# 19LC-012

# STAFF REPORT

1728 Avenue M

Certificate of Appropriateness to install a driveway with three parking spaces in the front yard.

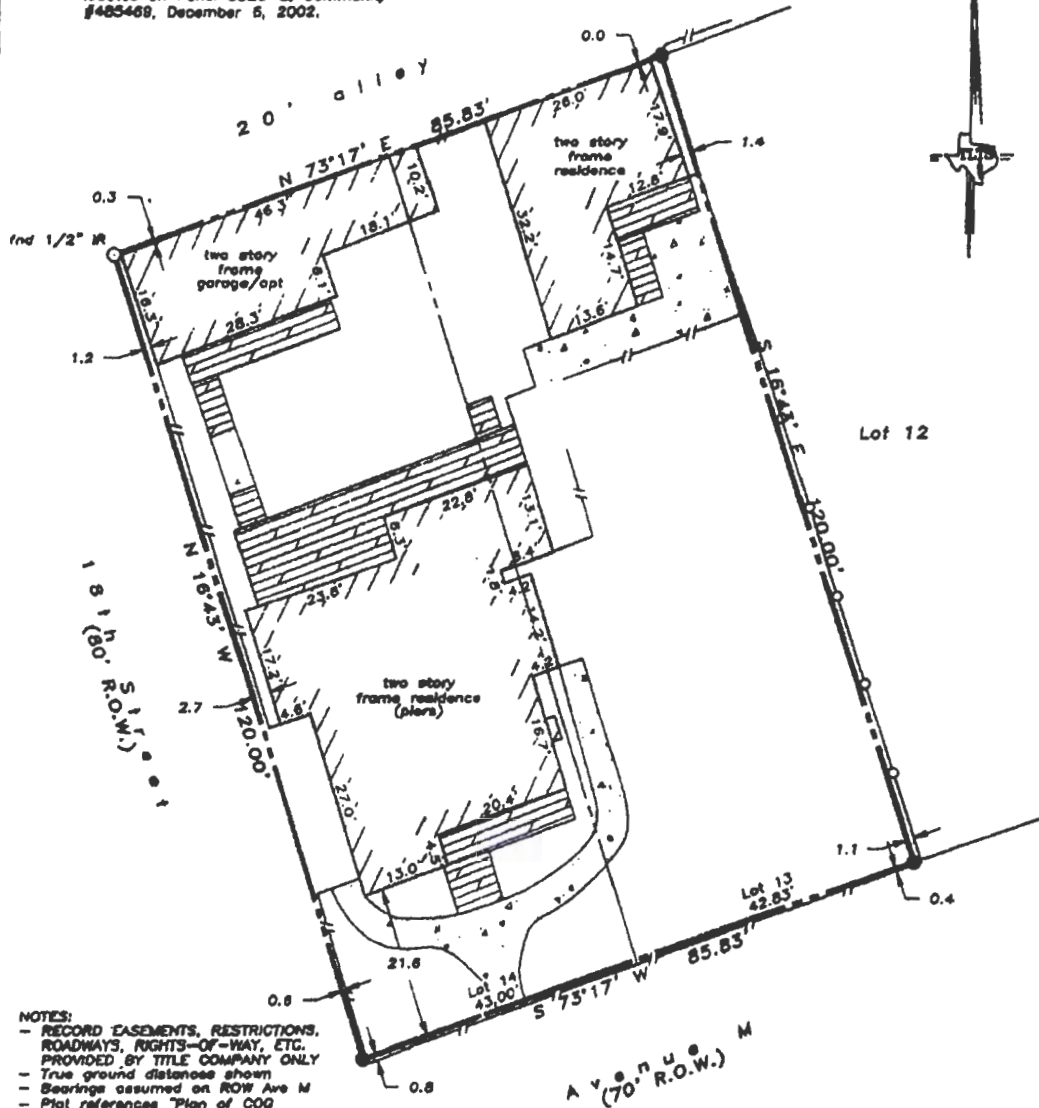
The *Design Standards* encourage driveways to be located in the rear or side whenever possible. This is a corner property with access from 18<sup>th</sup> Street and from the alley. There is an existing single car garage in the rear of the property facing 18<sup>th</sup> Street and a two care garage in the alley. Additionally, the *Design Standards* state that front yard paving for parking is prohibited. Staff finds the request not to be in conformance with the Design Standards.

Due to non-conformance with the Design Standards, staff recommends the Certificate of Appropriateness to install a curb cut, driveway and three parking spaces in the front yard be denied.

- 1. The exterior modifications shall conform to the design, materials and placement presented in Exhibit A of the staff report;
  - a. The maximum width of the entire curb cut shall not exceed 15’ in width;
